8th ENC WG MEETING

S-101 Attribute Nature of Construction “Latticed” in Geo Feature Beacon Special Purposes General

Submitted by:	Pushidrosal
Executive Summary:	Proposed consideration to obtain an automatic encoded value Latticed for the Nature of Construction Attribute on the Beacon Special Purposes General Geo Feature when converting S-57 to S-101.
Related Documents:	S-57 Appendix B.1 Annex A (UOC Edition 4.3.0), S-65 Annex B Edition 1.1.0.
Related Projects:	S-57 to S-101 Conversion

Agenda 5.6

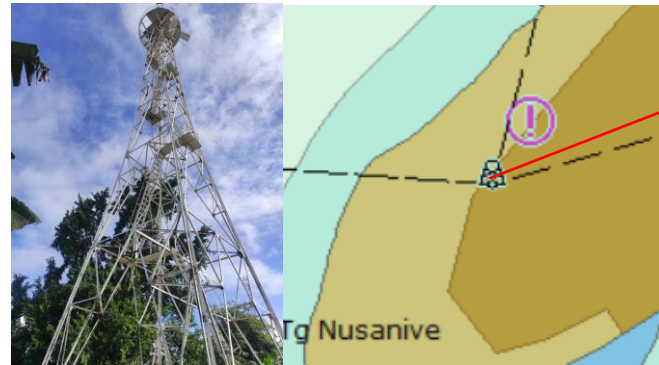
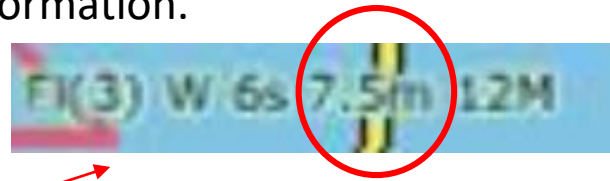
The other software does not show any critical errors because it is automatically fills the Beacon shape attribute with the encoded value of Pile beacon, even though in fact Pile beacon is not an appropriate value to replace Lattice beacon, but rather Beacon tower.

However, according to the IHO definition, a Beacon tower is a structure with a height (VERLEN) of 10 meters or more. Therefore, changing the default value of Pile Beacon to Beacon Tower on S-101 must be done manually.

Note: BCNSHP = 4 (lattice) depreciated in S-101. Encoding moved to Nature Of Construction. Beacon Shape set to '5 (pile)' by default, consider if '3 (tower)' may be appropriate for this feature.

Lattice beacon with Height less than 10 meters.

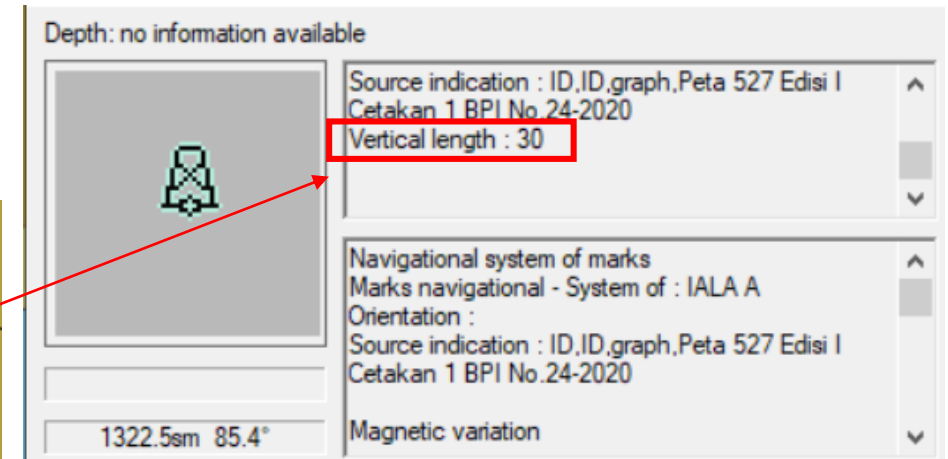
- this will be quite a lot of cartographic work considering that in Indonesia there are huge numbers of BCNSPP within BCNSHP = “Lattice Beacon” which have varying heights above 10 m or less than 10 meters.
- automatic filling during conversion not only makes it easier to load ready conversion workload but also avoids missing-information.

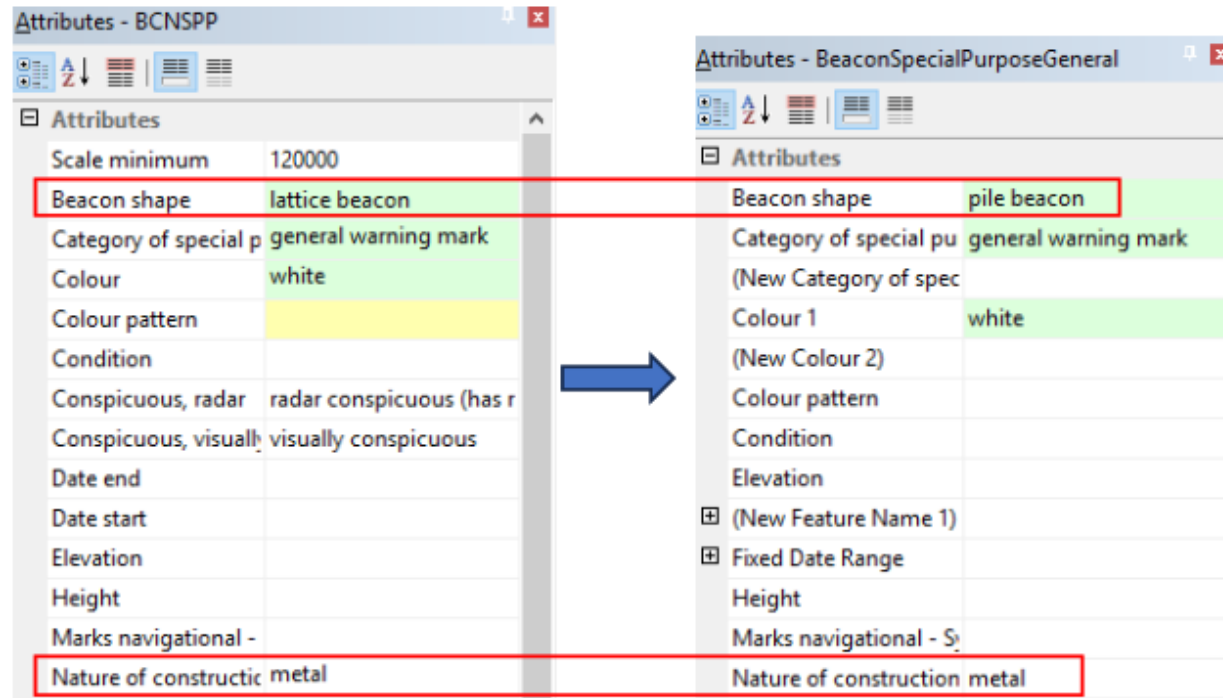
If on S-57 there is a BCNSPP with “Lattice Beacon” and it has a NATCON value, for example “Metal”, then after the conversion to S-101, latticed information does not move automatically to NATCON

Lattice information has missing, so its not possible to filter the “latticed” BCNSHP which is converted into a “Pile beacon” to be converted to a “Beacon tower” manually.
